RELIEF AND RECONSTRUCTION
FUNDED WORK AT MOSUL DAM
MOSUL, IRAQ

SIGIR PA-07-105
OCTOBER 29, 2007

SUBJECT: Report on Relief and Reconstruction Funded Work at Mosul Dam, Iraq
(Report Number SIGIR PA-07-105)

Figure 6. Illustrative example of the Mosul Dam’s grouting program aimed at filling voids and cavities from the gallery (Figure courtesy of USACE)

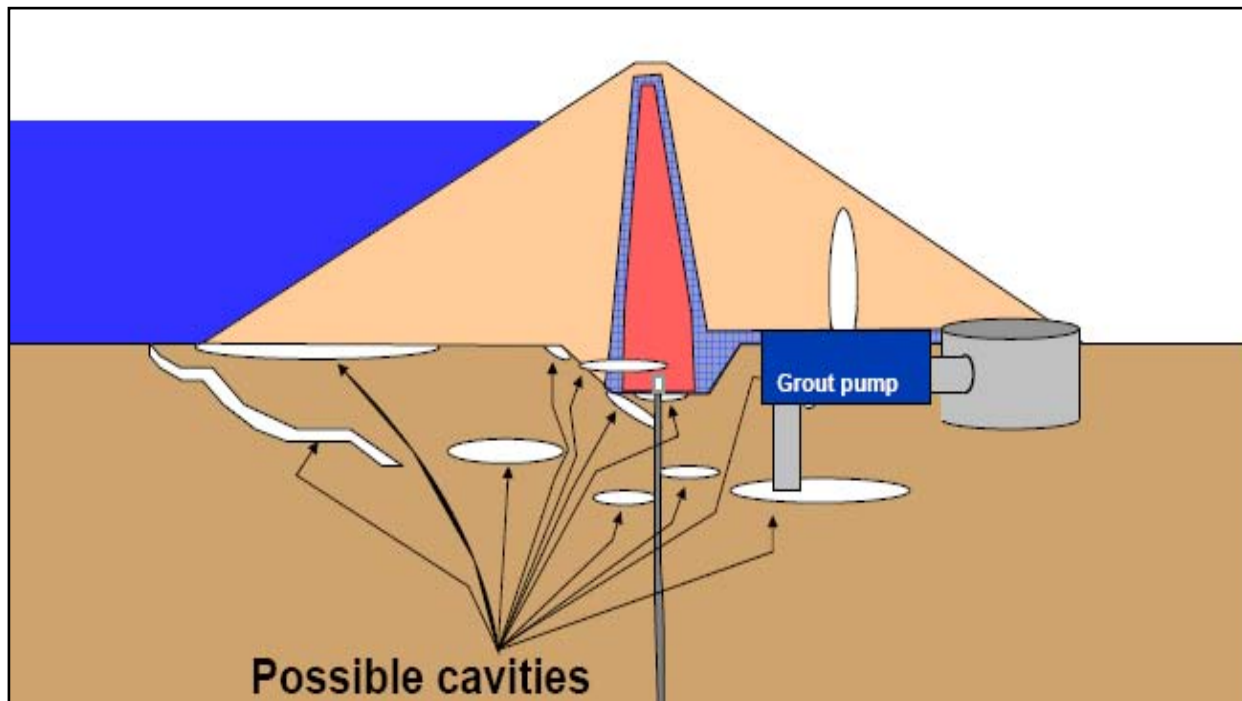
Page 10, Figure 7. Mosul dam engineers do not have means of “filling cavities” away from the grouting gallery. Figure 7 shows a grout pump filling a cavity downstream from the gallery; there is no means available to achieve this. Grouting can only occur from the grouting gallery. Suggest removing this figure.

Figure 12. Contractor's design drawing for 30-m³/hour concrete-mixing plant

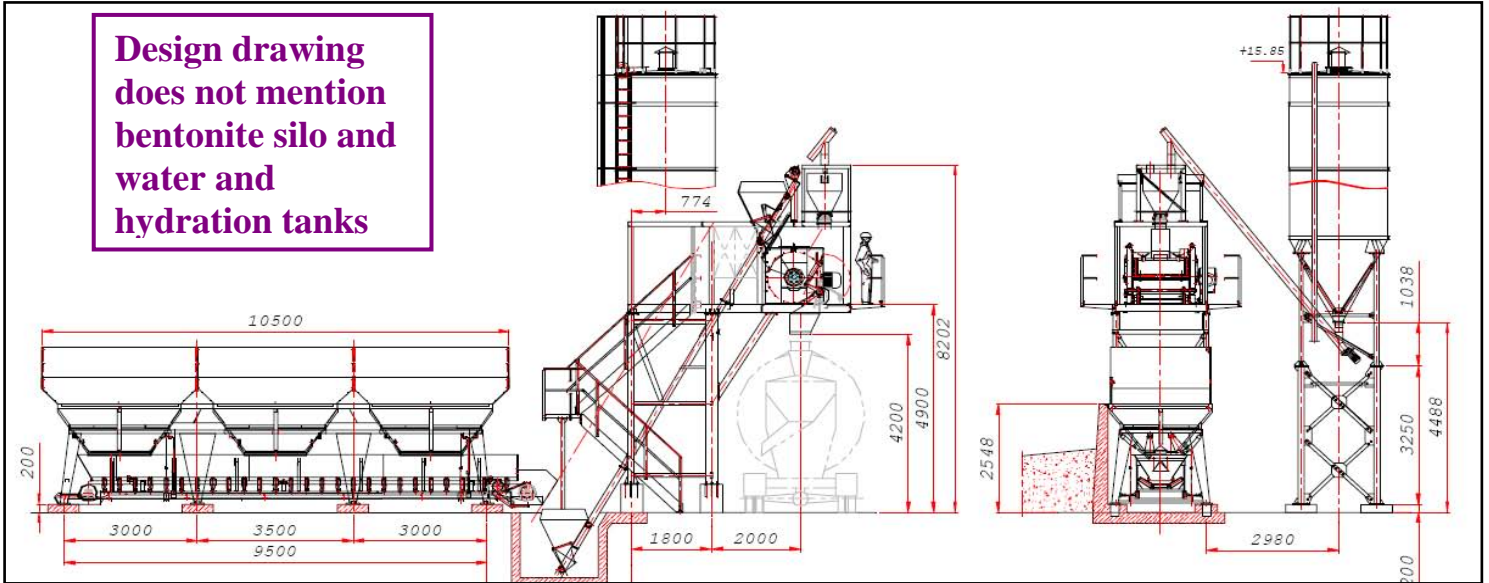
GRD provided the contractor's design submittals for the two sizes of grout-mixing plants (i.e., 30-m³/hour and 100-m³/hour), which we reviewed. For the 30-m³/hour grout-mixing plants, our review of the design drawings concluded that the contractor was clearly offering concrete-mixing plants, not grout-mixing plants (Figures 12 and 13). Grout mixing plants require a bentonite silo and water and hydration tanks, associated weighing and measuring devices, additional pumps and motors, which were not included in the design drawings.

In our opinion, the 100-m³/hour mixing plant design submittal also clearly indicated the contractor was offering a concrete-mixing plant, not a grout-mixing plant (Figure 15). The design submittal lacked a bentonite silo, water and hydration tanks, associated weighing and measuring devices, and additional pumps and motors, which are essential for a grout-mixing plant (Figure 13).

Figure 13. Contractor's design drawing for 100-m³/hour concrete-mixing plant

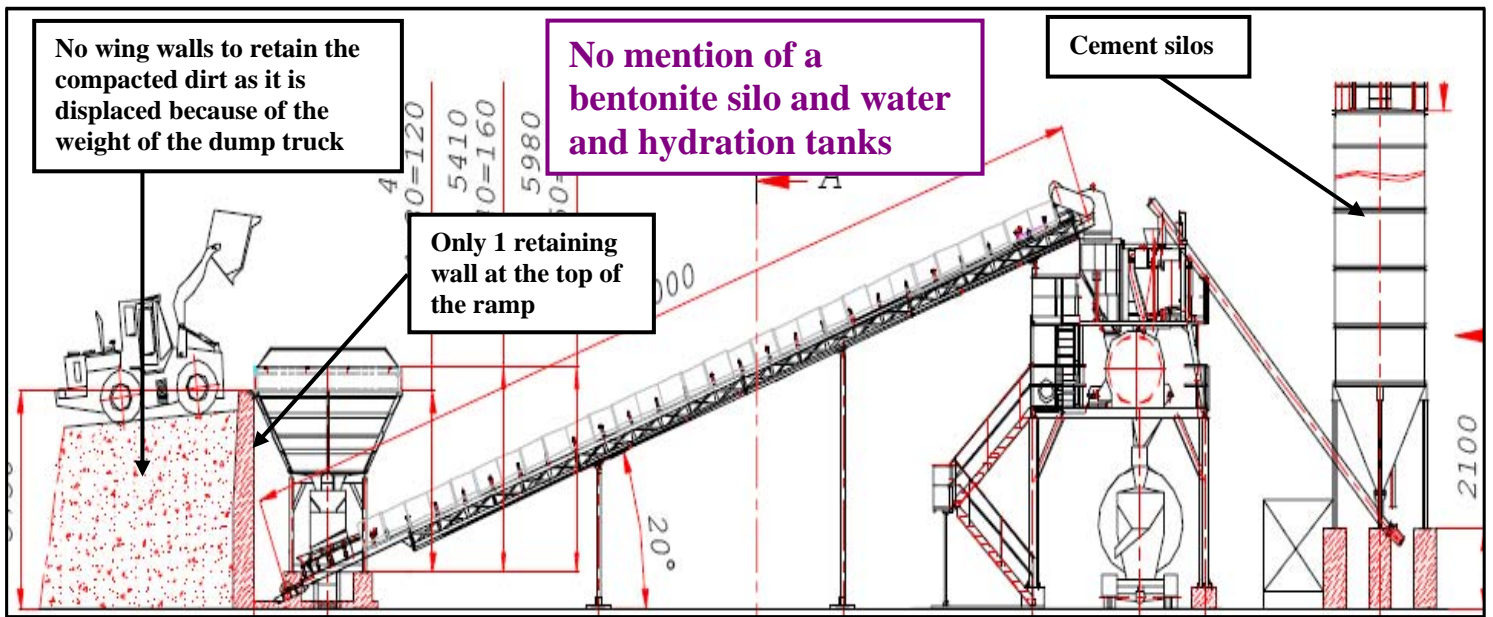
The July 2006 CH2MHill/Parsons’ memorandum did not mention the 100-m³/hour grout-mixing plant. The contract file lacked any documentation regarding how the concrete-mixing plant was reviewed and approved instead of the required grout-mixing plant. It appears that for the 100-m³/hour grout-mixing plant design submittal, the EC also did not “notice” the contractor’s submittal offer was for a concrete-mixing plant, not a grout-mixing plant. In addition, the EC did not recognize the contractor’s design submittal lacked side retaining walls (i.e. wing

walls) for the loading ramp (Figure 13). The wing walls are crucial for the use of the loading ramp because without them, when the full dump truck drives up the ramp, the compacted dirt will disperse under the truck's weight resulting in the truck not being able to reach the hoppers to unload the materials.

Figure 16. Top view of four stationary silos

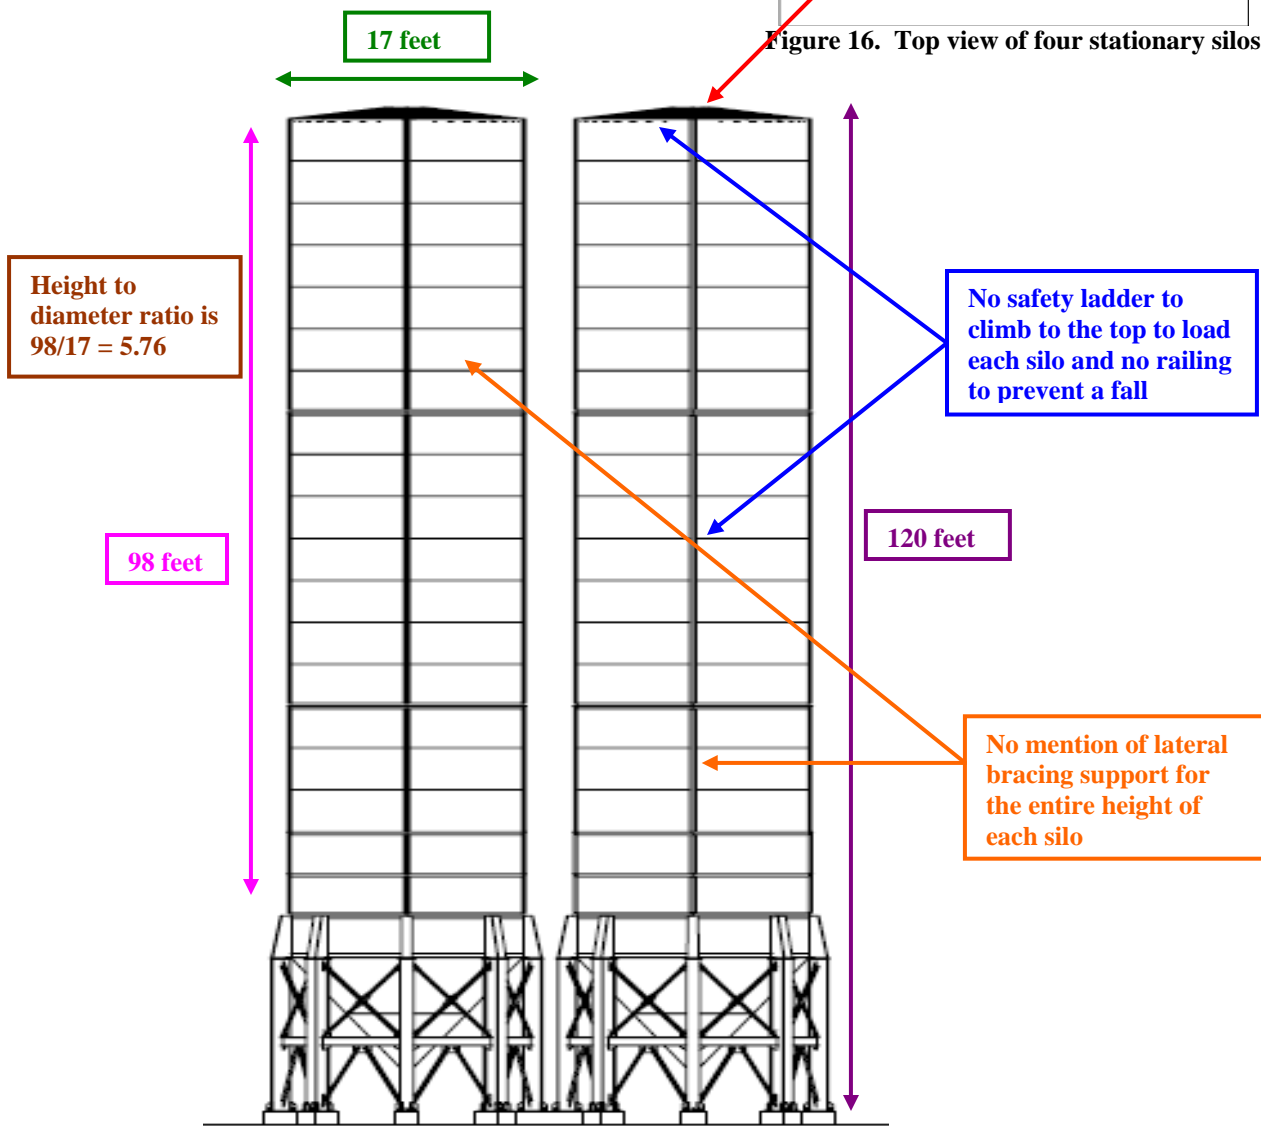
The "Plans and View [sic]" design submittal provided multiple views of the finished stationary silo (Figures 16 and 17). According to the design drawings, each silo was to be approximately 120 feet high (from the base to the top). After thoroughly reviewing all available design drawings, we found the designs lacked significant details, such as lateral bracing support for the entire height of the silos (Figure 19), notes for the thread size, length, washer size, base plate requirement, and torque (for the foundations bolts – Figures 18-21), how the MWR personnel will deposit cement into the silo, and safety concerns. The lateral bracing supports for the entire height of each silo are important in order to keep each silo in its intended vertical position while allowing the load to transfer to the matt foundation during the cement filling process. The proportion of the silos is very large, since the height to diameter ratio is almost 6 (Figure 17), which could result in the silos overturning. According to an internal GRD document, the "standard practice is to resist overturning by a ratio of 1.5." A consulting engineer for GRD stated the silos looked like an "inverted pendulum." Further, detailed information for the foundation bolts is critical, since the foundation bolts will be required to counter all gravitational forces that would cause the silo to tip over, under most conditions. Further, since the opening to fill each silo is located at the top (120 feet high), for safety reasons, we are concerned that the contractor's designs did not include a safety ladder to climb or a safety bar and railing at the top (Figure 17). Additionally, no secure walkway with safety railings is shown to connect all silos at the top.

Loading each silo occurs at the top

Height to diameter ratio is $98/17 = 5.76$

No mention of lateral bracing support for the entire height of each silo

Figure 18. View of column group for the stationary silos

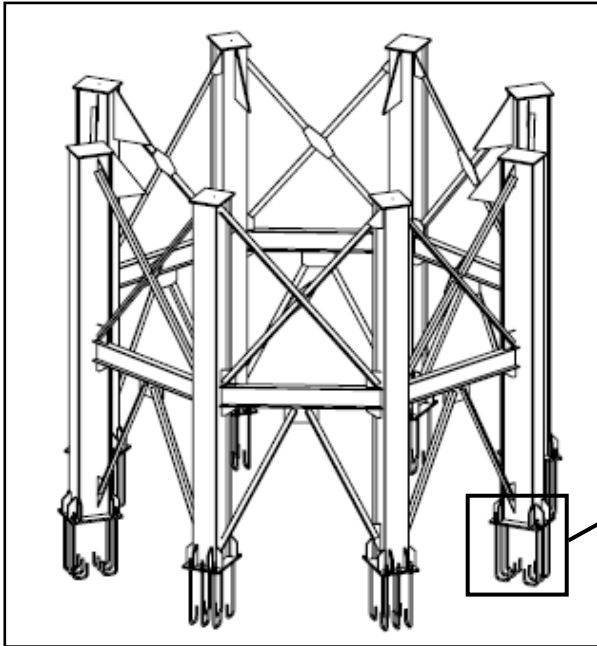
Design does not mention diameter size, thread size and length and strength grade for steel

Figure 27. The contractor's design drawing for the 30-m³/hour concrete-mixing plant (Colored arrows identify pieces found at the site and what relationship they are to the design) (Areas circled in blue are equipment required by the design that could not be accounted for/located during site visit)

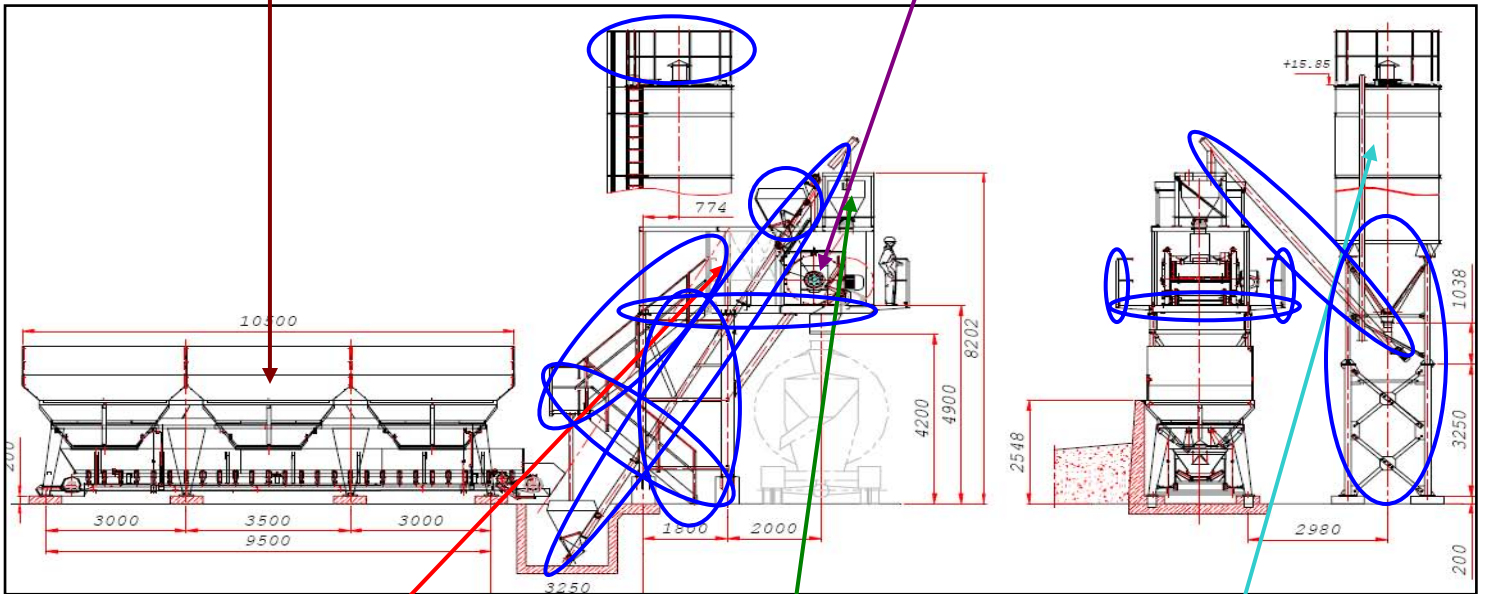
On 12 September 2007, we observed the pieces of an unassembled 30-m³/hour concrete-mixing plant (Site Photos 12-16). After reviewing the contractor's design submittals for the 30-m³/hour concrete-mixing plant (Figure 27), we attempted to determine if all the mixing plant pieces were delivered. The available pieces did not appear to be adequate to fully construct either a grout or concrete-mixing plant. It appeared that several items were missing, such as screw conveyor, pipes, and air compressor. Considering the contractor used one of the four silos dedicated for the 30-m³/hour mixing plants, it will not be possible to construct both mixing plants.

Figure 28. Requirements of the design drawings

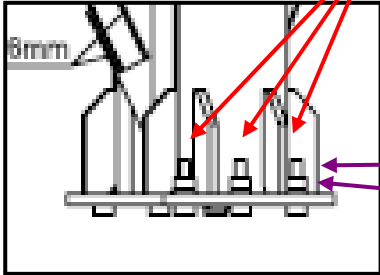
Contractor's design drawings required bolt threads extend beyond the nut and washer
